Re: Federal Docket No. FHWA-2020-0001
National Standards for Traffic Control Devices

Attachment:
Caltrans Comments on National MUTCD Revisions

Comments on Docket No. FHWA-2020-0001 (RIN 2125–AF85) National Standards for Traffic Control Devices; the Manual on Uniform Traffic Control Devices for Streets and Highways; Revision

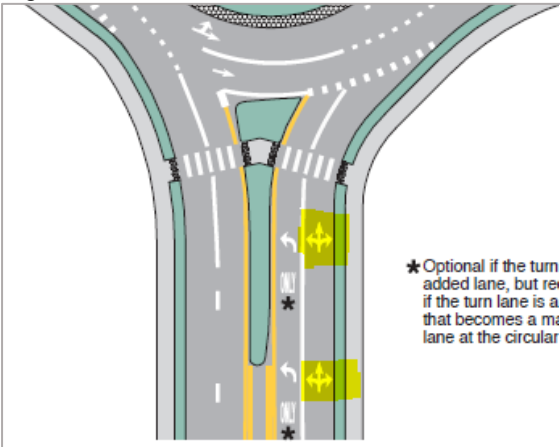
3B.25 – Chevron and Diagonal Markings	YES			<p>Page 364, Line 29. Suggest adding a distance range, or specific spacing based on roadway speed (i.e. 50'-100' for 45 MPH or greater, 25' for 45 MPH or less), for longitudinal spacing of chevrons or diagonal line markings. Leaving it to engineering judgement will result in inconsistent spacings for various speeds. There should be a basic starting point or guidance for engineers to use.</p>
3B.25 – Chevron and Diagonal Markings	YES			<p>Page 364, Line 35. Caltrans has adopted 6-inch stripes, not sure if we have equipment to comply with previous 4" standard. May need to adjust standard in CA MUTCD version.</p>
3B.31 & 3C.11 – Markings for Diamond Interchange with	NO	NO	YES	<p>Figure 3B-29 and Figure 3C-3 are missing. MUTCD proposes a new concept, but the detailed Figures for this Section are missing.</p>

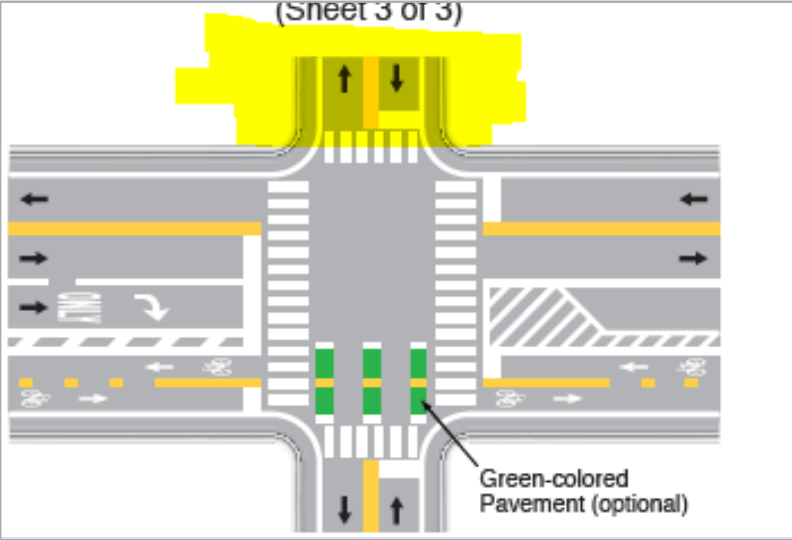
9B.21 – LEFT TURN YIELD TO Bicycle Sign (R10-12b)	NO	YES	YES	LEFT TURN YIELD TO Bicycles Sign (R10-12b): The application of these signs is very limited. Expand allowed uses.
9E.01 – Bicycle Lanes	YES	YES	NO	Line 33-40 p. 767 – Clarification is needed to determine whether shoulders at interchanges can be used to accommodate bicyclists. Utilizing interchange shoulders to minimize conflicts between bicyclists and motorists may be beneficial. Clarify if bicycle lanes to the right of an edge line are considered shoulder as a bikeway.
9E.01 – Bicycle Lanes	NO	NO	YES	Disagree with concept of “A portion of travel way shall not be established as both a shoulder and a bike lane.” The proposed MUTCD language is inconsistent with the California Highway Design Manual (HDM). HDM shoulder standards would need to be revised, or a Design Standard Decision Document (DSDD) for non-standard shoulder widths will be needed when converting shoulders to bicycle facilities. Not allowing bike lanes to be considered shoulders for emergency purposes may greatly hinder our ability to install bike lanes in many locations where signing and striping assist in increasing awareness that cyclists are present in the area. The default may become using the Bicycles Use Shoulder Only sign if a DSDD cannot be obtained for non-standard shoulder widths. Use of the Bicycles Use Shoulder Only sign does not provide the same level of awareness and potentially same level of safety as class II bikeway treatments such as additional signing and striping including buffers and green markings.

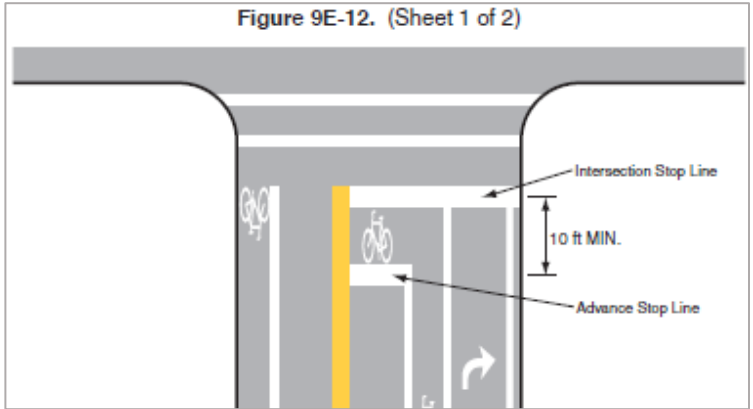
9E.07 – Separated Bicycle Lanes	NO	NO	YES	<p>The Guidance (page 772, lines 39-40) reads, “<i>BIKE LANE (R3-7) signing should be used where a separated bicycle lane may be confused for a general purpose lane.</i>”</p> <p>What is the purpose of sign R3-7 here? Also, we recommend moving this statement to Section 9D.</p>
9E.08 – Counter-Flow Bicycle Lanes	NO	YES		<p>Two consecutive sentences in the Support” section appear to contradict each other: “Counter-flow bicycle lanes are one-directional...” is followed by the next sentence stating, “Counter-flow bicycle lanes establish two-way traffic on a roadway.” Suggest verbiage in one or both sentences be modified to eliminate the appearance of being irreconcilable.</p>
9E.09 – Shared-Lane Marking	NO	YES		<p>Agree with the concept that “Shared-Lane Markings should not be placed on roadways that have a speed limit above 40 mph or more. (P. 775, line 12-13), however, this section should go further to specify where shared-lane markings are/are not appropriate. Caltrans contextual guidance recommends Class III facilities (shared-lane markings) under 30 mph where Design Year ADT is less than 5,000, except in rural developing corridors where a shoulder may be designated as a Class III. Would suggest this section provide more context on where Class III are appropriate, including vehicular volume levels, and underscore that Class III facilities are not appropriate for</p>
